# Technical Service Bulletin

## 91 MIB MMI: Facebook not available through Audi connect

91 15 91 2040939/1 June 12, 2015.

Model(s)	Year	VIN Range	Vehicle-Specific Equipment
A3	2015 - 2016	All	Audi connect
A6, A7	2016	All	Audi connect

Figure 1. Message in MMI.

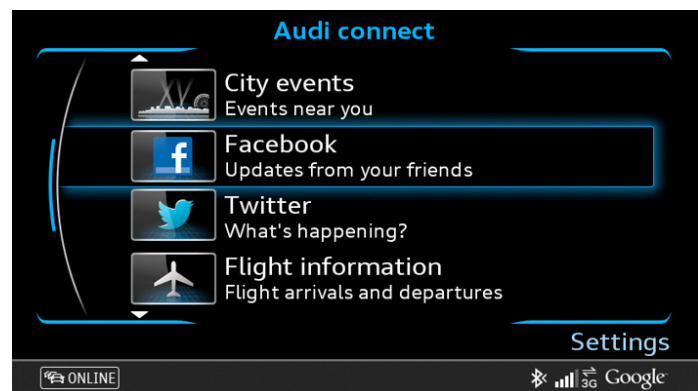
- The customer's Facebook newsfeed can no longer be accessed via Audi connect. The message "Dear customer, this service is no longer supported by Facebook" appears in the MMI display (Figure 1) and in the myAudi customer portal. This message will only appear between June 1, 2015 and July 1, 2015.
- The option to select Facebook in the MMI (Figure 2) is not available and Facebook cannot be configured within the myAudi customer portal.

Explain the *Technical Background* to the customer.
